CITY OF SUPERIOR, WISCONSIN
 DEPARTMENT OF PUBLIC WORKS

CONTRACT NO. 3
 LIFT STATION 5 AND STORAGE PLAN

CONTRACT NO. 3
LIFT STATION & STORAGE IMPROVEMENTS

LIFT STATION & STORAGE IMPROVEMENTS

FOUNDATION PLAN - LIFT STATION No. 5
 SCALE: 1/8" = 1'-0"

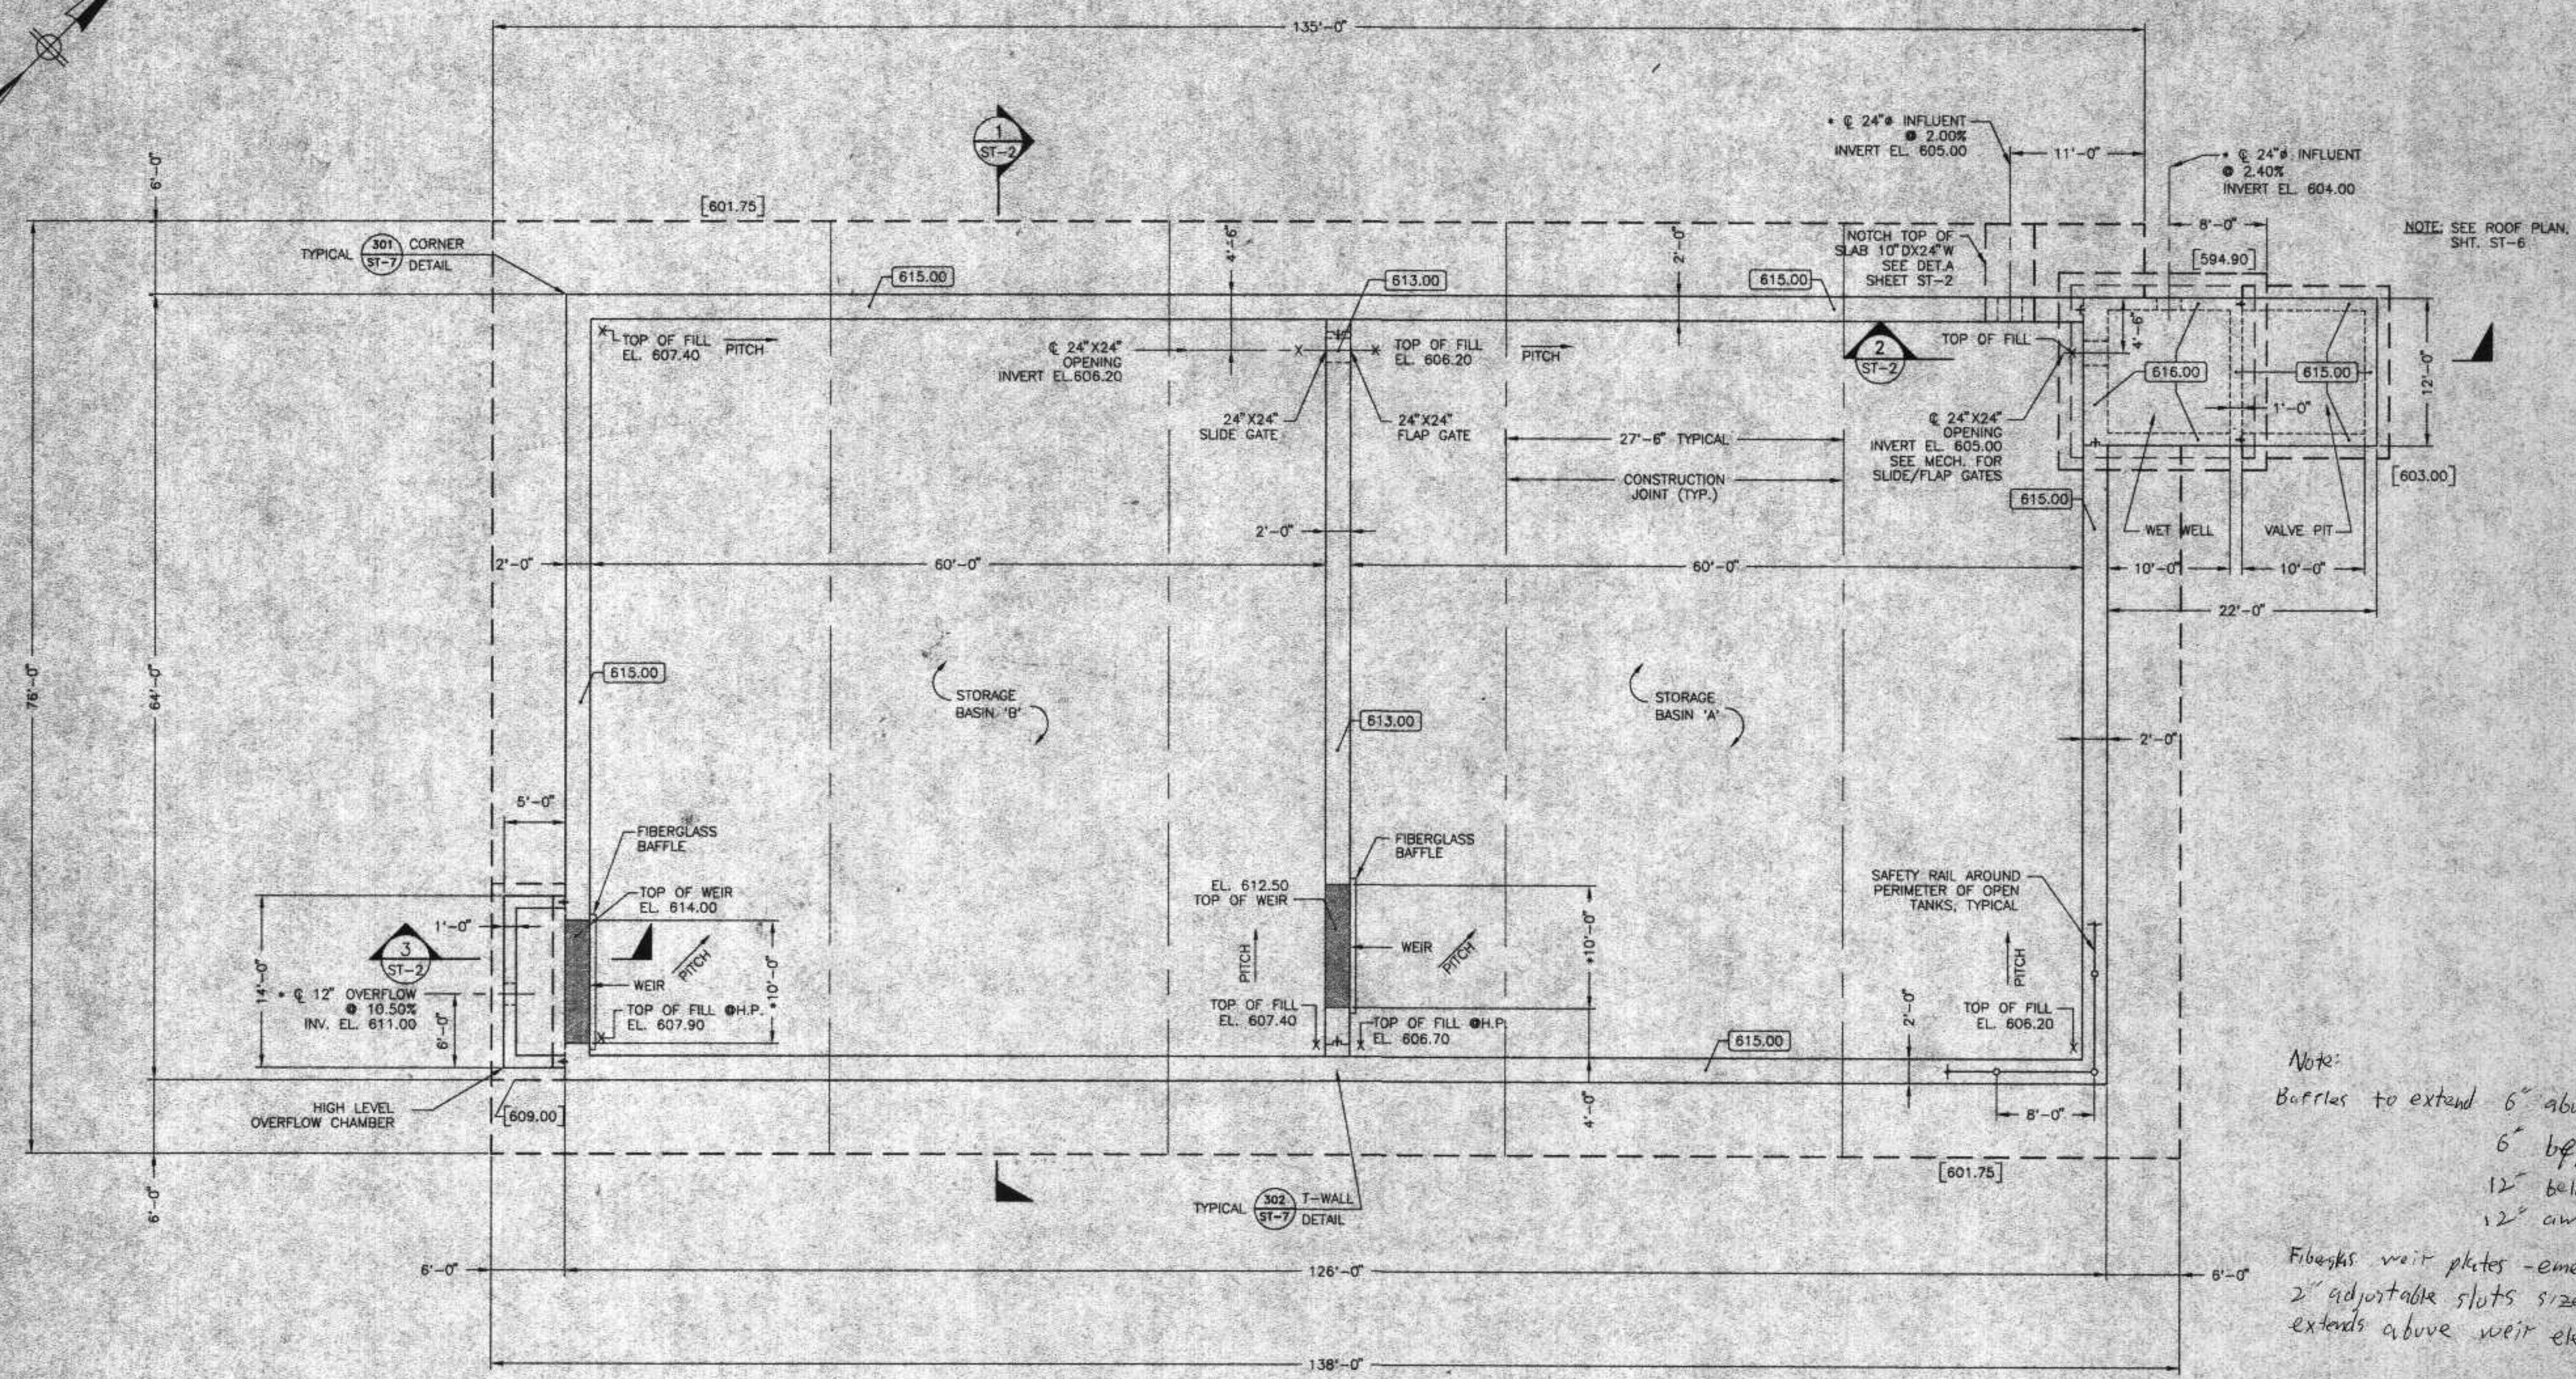
Note:
 Baffles to extend 6" above weir elev
 6" beyond weir ends
 12" below weir
 12" away from wall
 Fiberglass weir plates - emergency overflow weirs
 2" adjustable slots sized so 4" of plate
 extends above weir elev when closed

1. Add Note: baffles to extend 6 inches above concrete weir elevation, 6 inches beyond their ends, 12 inches below concrete weir elevation and 12 inches away from wall.
2. Add Note: fiberglass weir plates to be provided at emergency overflow weirs with 2" adjustable slots sufficiently sized so that 4" of plate extends above concrete weir elevation when centered.

END PLAN LIFT STATION 5

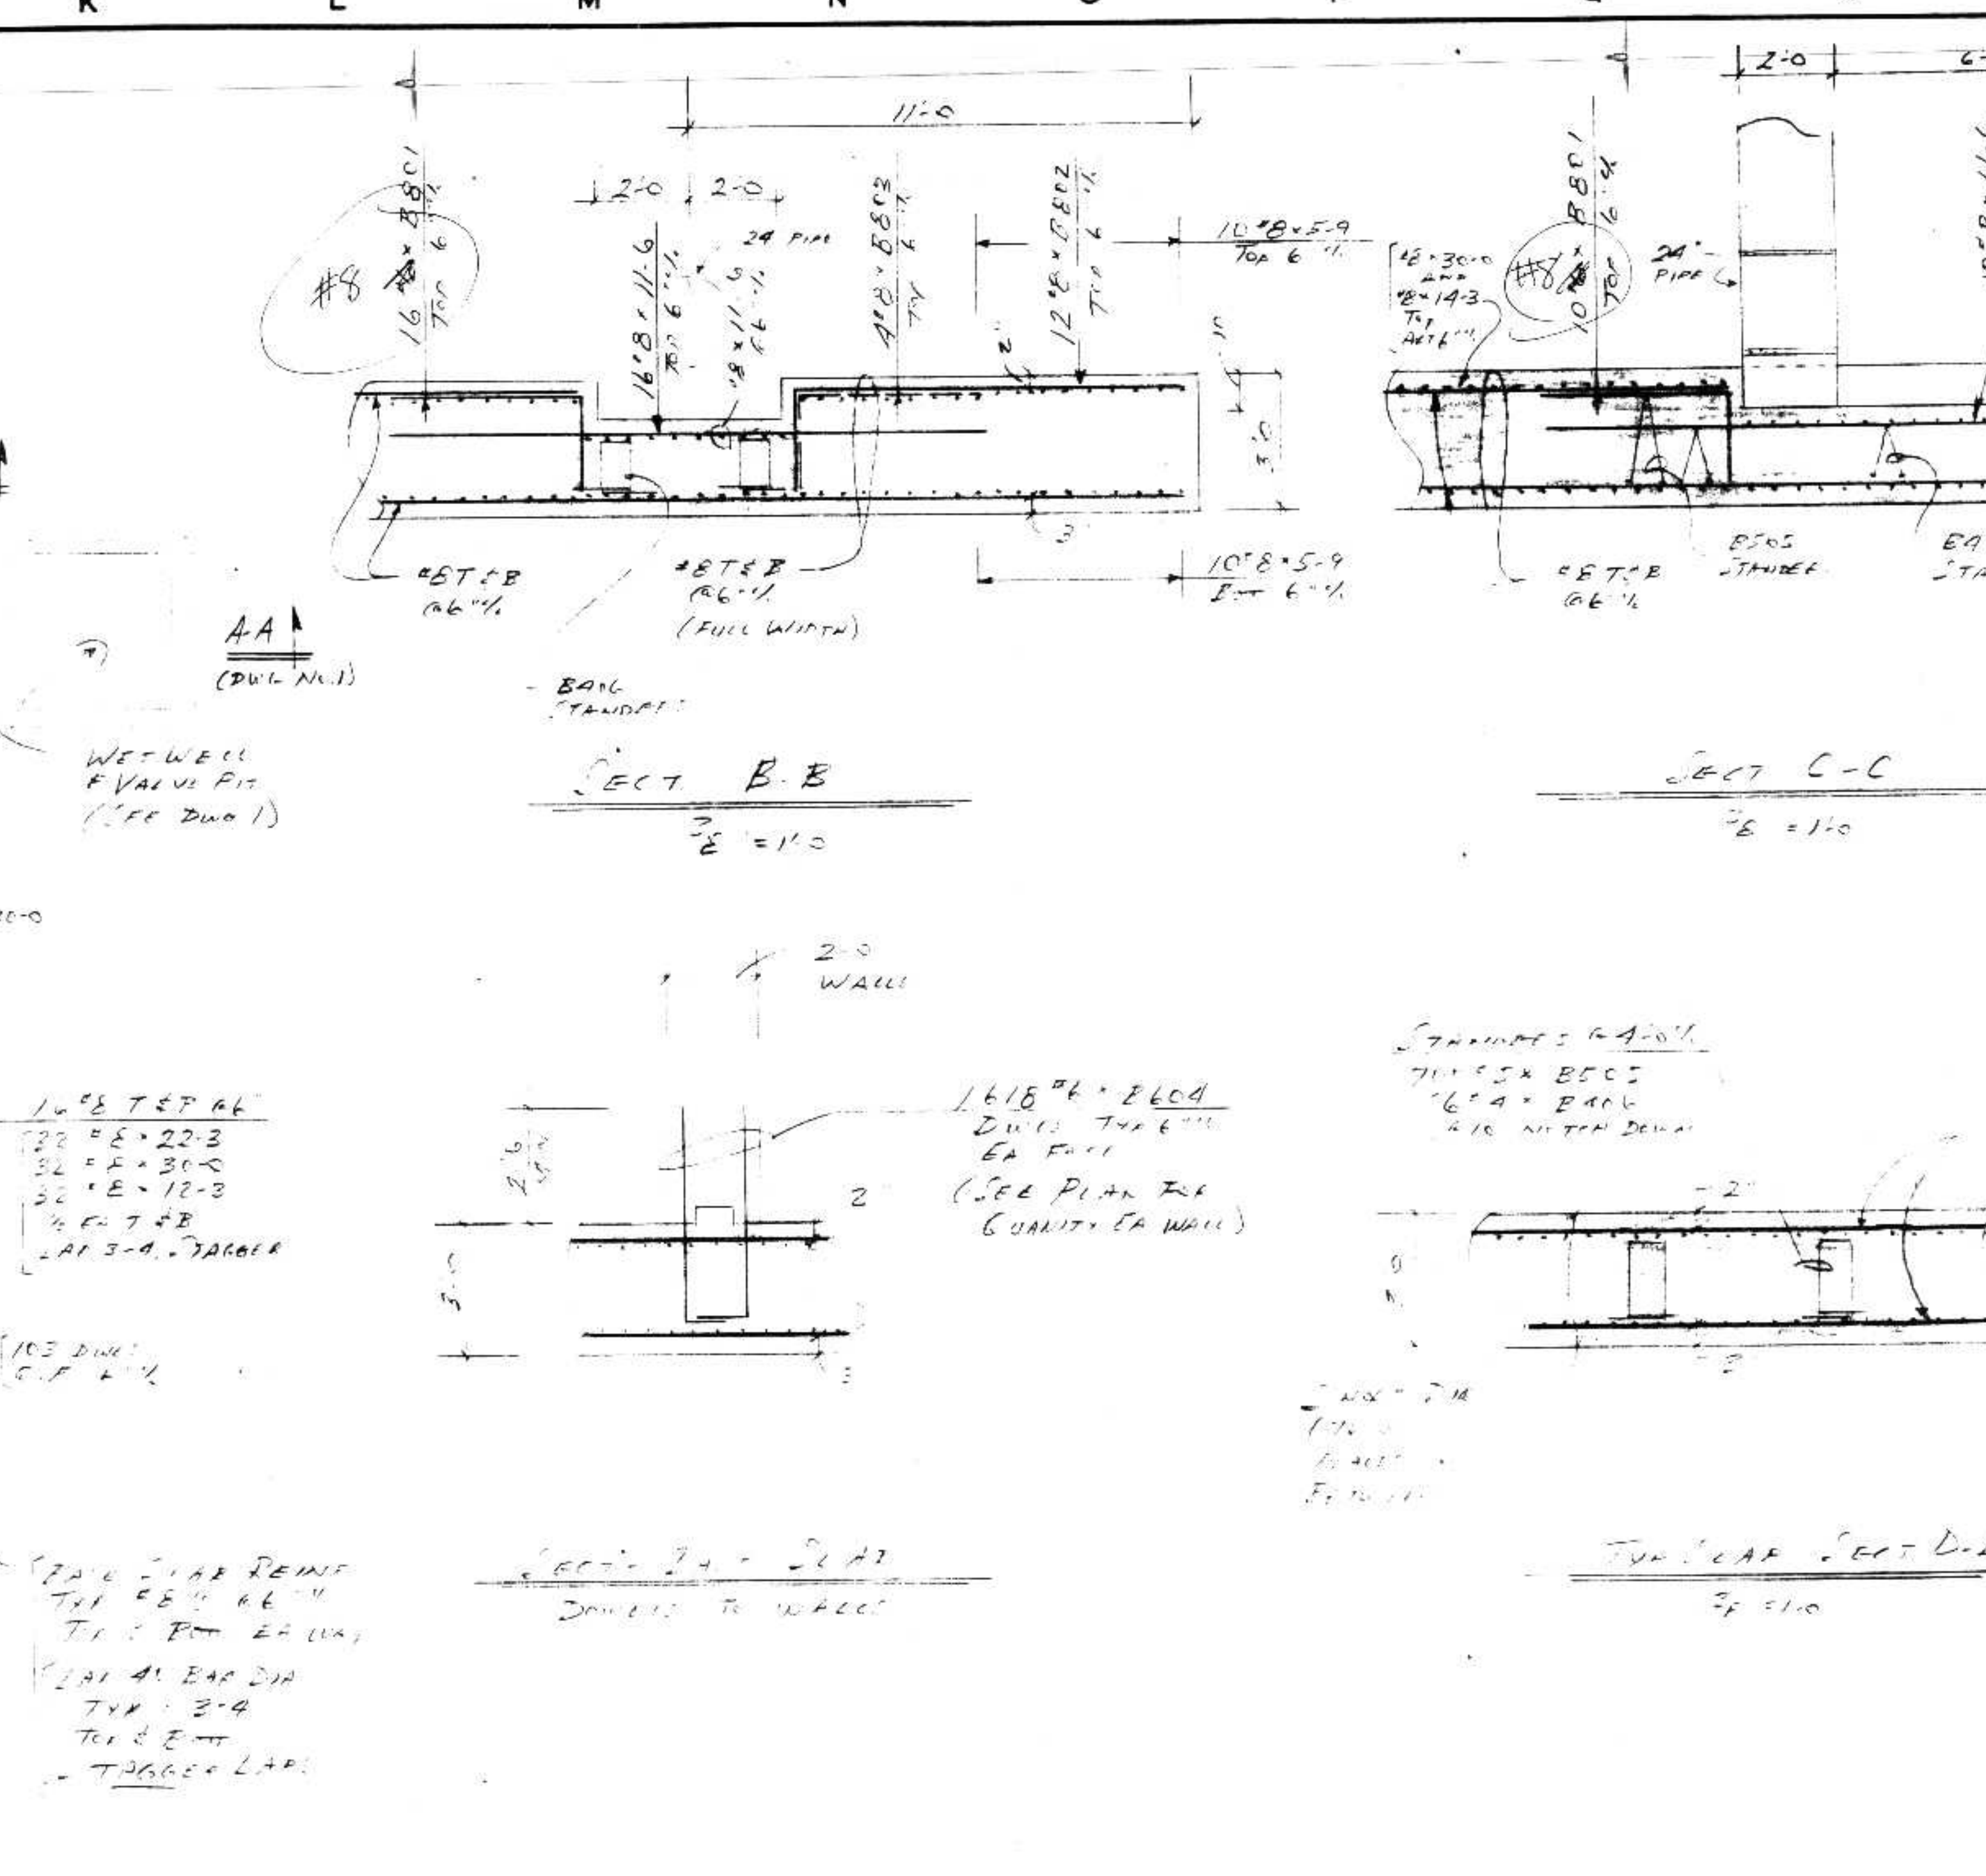
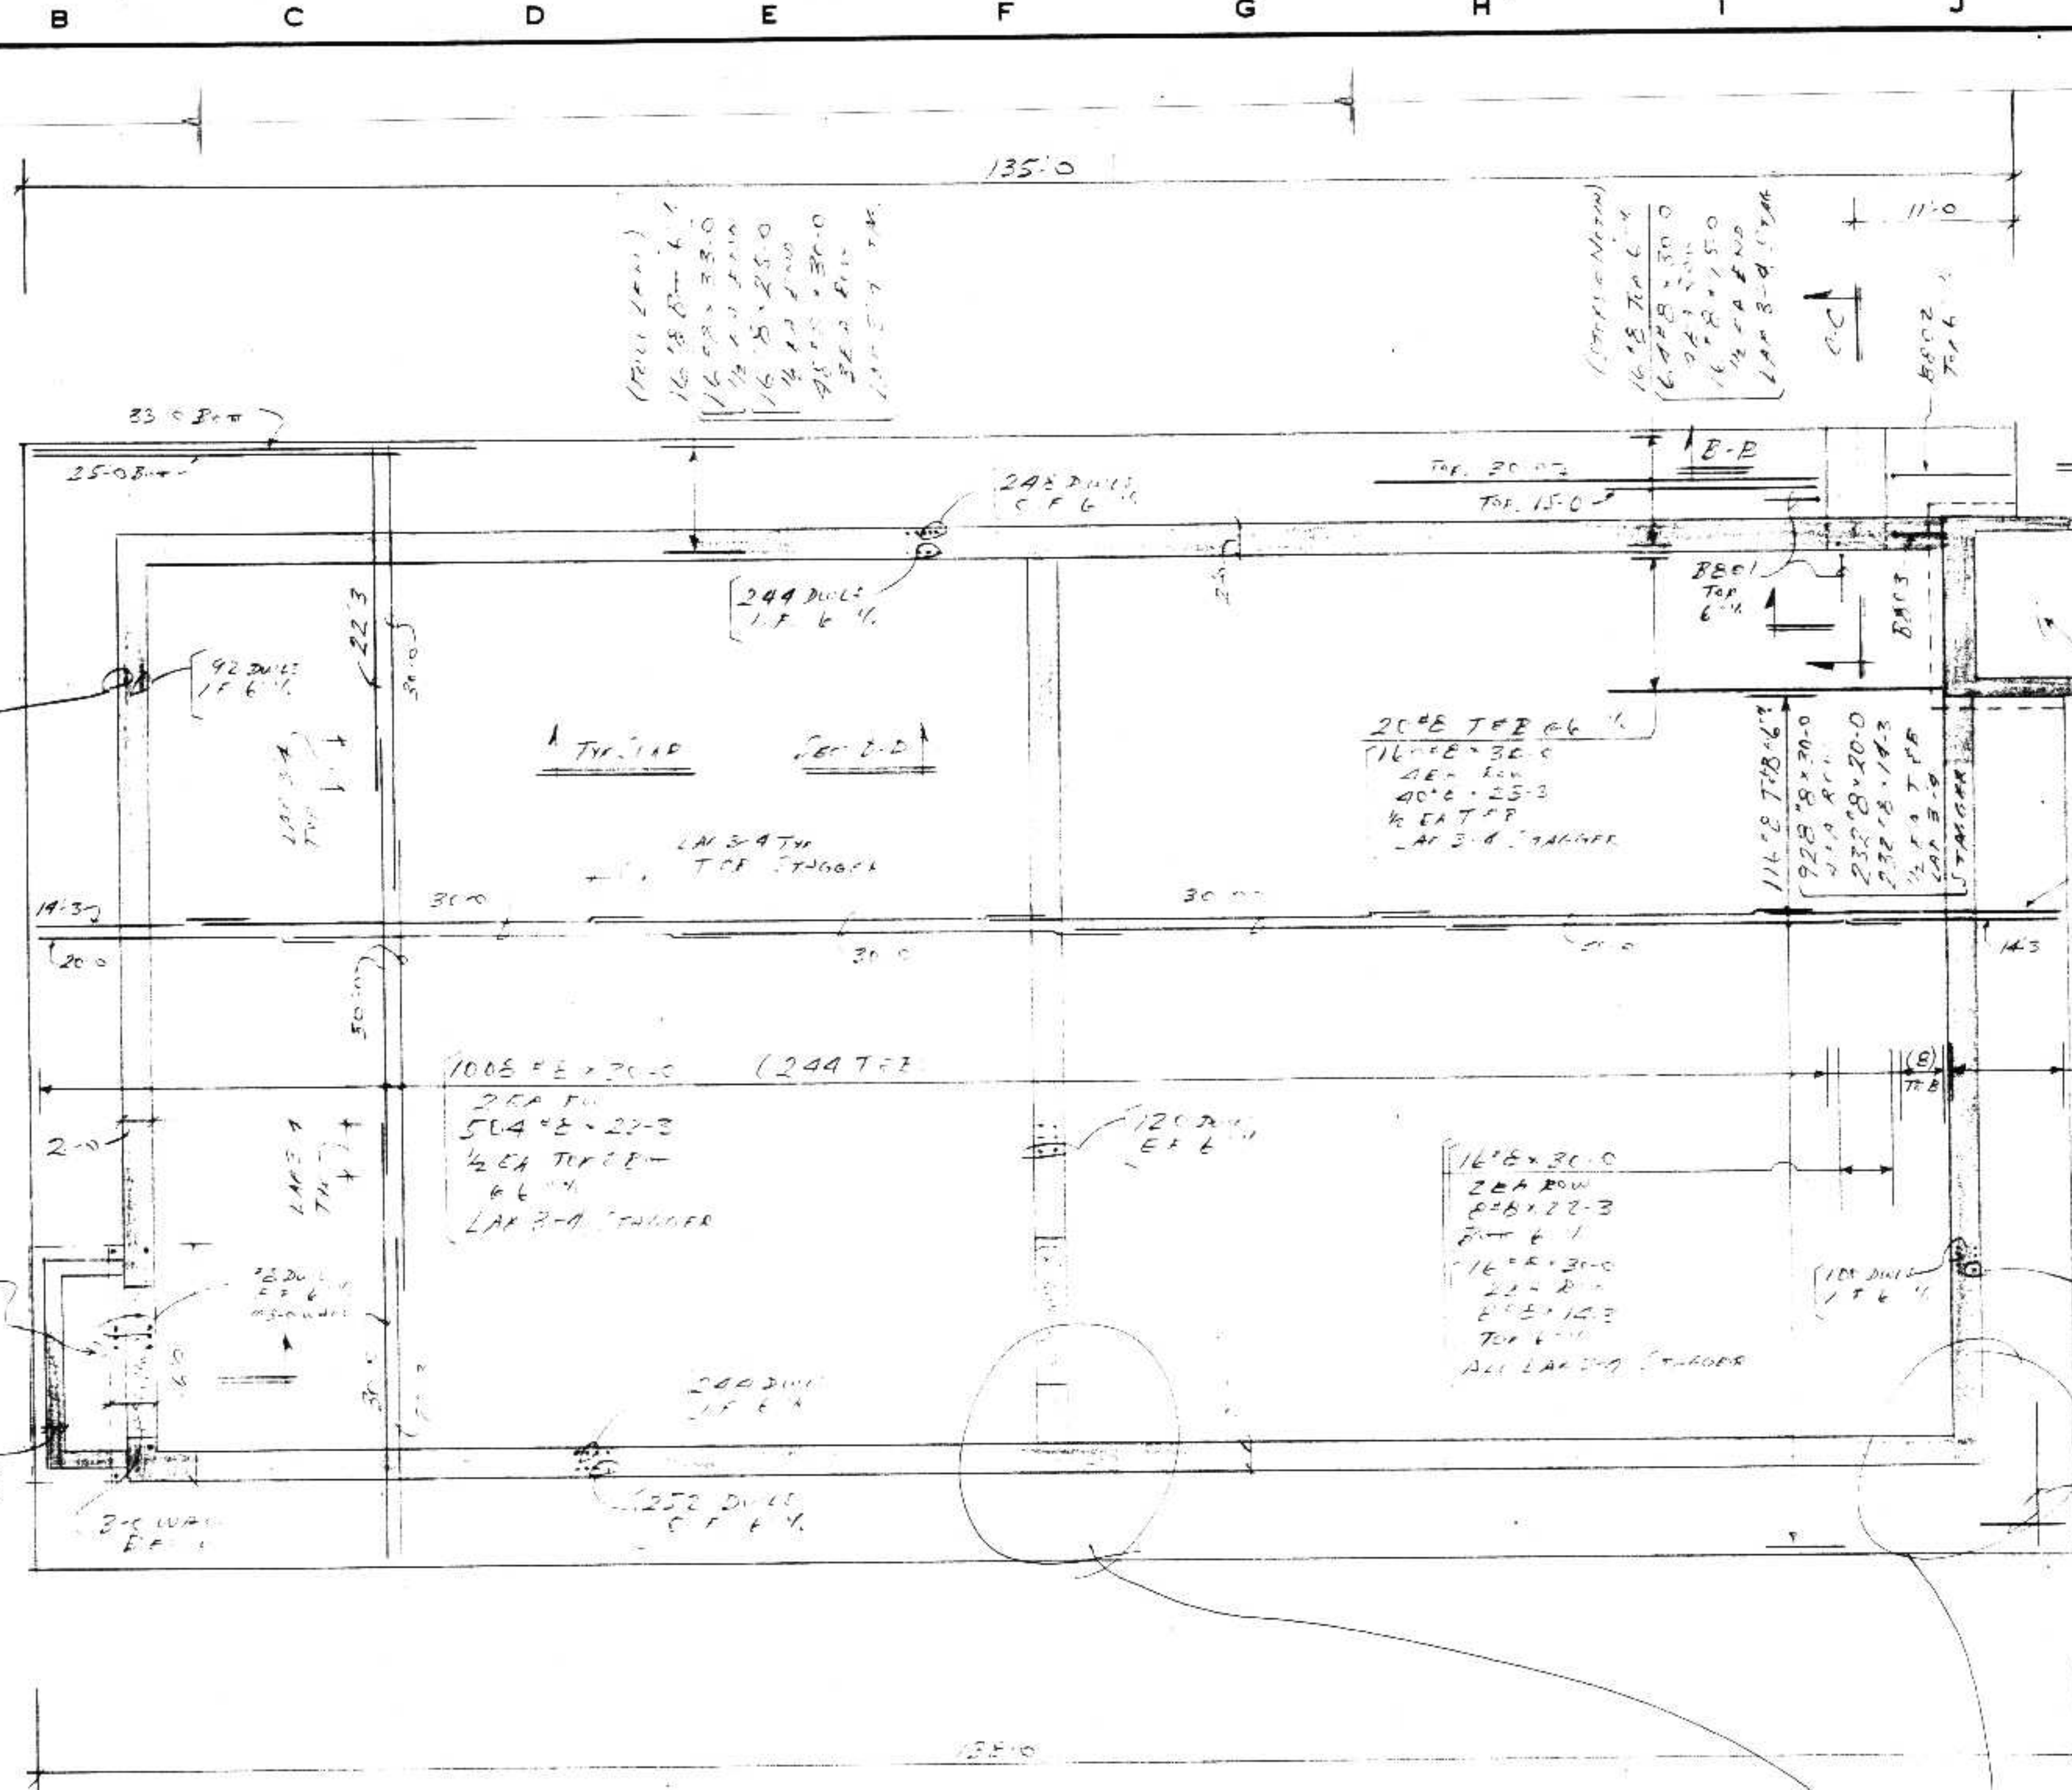
Please show corner & intersection details similar to 301, 302 ST-7, ST-7 from contract drawings
